Airstream Service Bulletin

Bulletin Number: #194

Product Line: Interstate 19 and Interstate 24

Subject: Exhaust Vent Firefly Software Update

USB screen and CLC upload instructions:

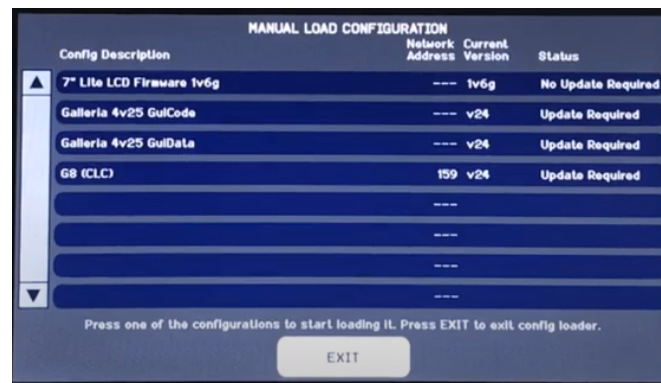
1. The USB (32GB or less) drive must be formatted as FAT or FAT32. We find that smaller USB sticks seem to work best (8GB or less). Both files combined are around 1 MB.
2. On the USB drive, create a folder at the root level named "SpyderConfig" (Not case sensitive). For example: If your USB drive shows up as D: on your computer, this should be D:\SpyderConfig

4. Copy the attached software files into the "SpyderConfig" folder (**cli.bin and mcf.bin – these files CANNOT be renamed**).

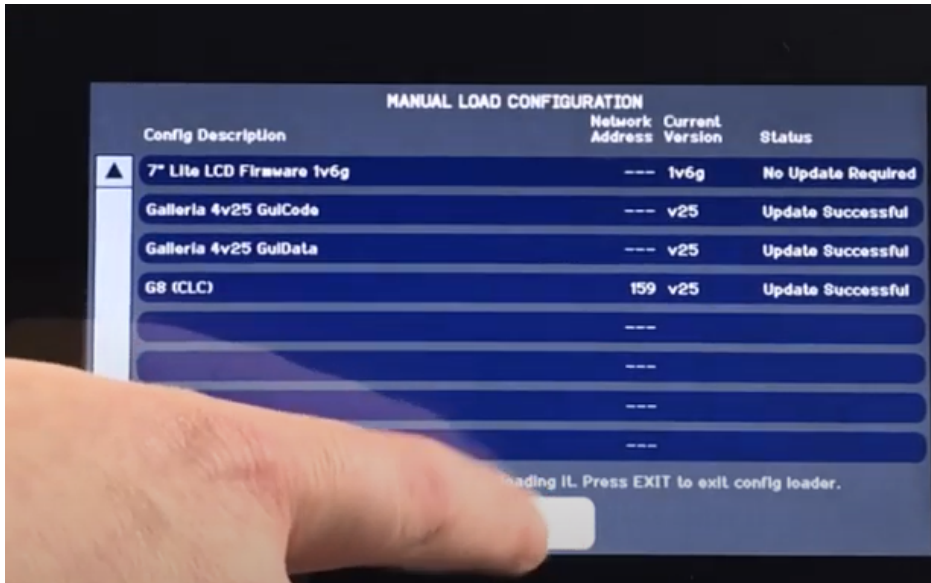
5. Plug the USB drive into the back of the screen.
6. Power cycle the screen. For a minimum of 10 seconds.
7. On the new screen page, select "Manual." There should be at least 4 entries under the "Config Description" header:
 - a. Firmware
 - b. GuiCode
 - c. GuiData
 - d. CLC Device i.e., G12 "7" screen shown below"

If you do not see at least 4 entries, take a picture, and contact support@fireflyint.com or call 1-574-825-4600.

8. If you have at least 4 entries, press:
 - a. Firmware button first, even if it says “No Update Required.” Wait for status to say, “Update Successful.”
 - b. GuiCode button, even if it says “No Update Required.” This will also load the GuiData line, so wait for both files to finish.
 - c. Finally, press the CLC button, even if it says “No Update Required.”
9. Once everything is complete, and all entries say “Update Successful,” press Exit.
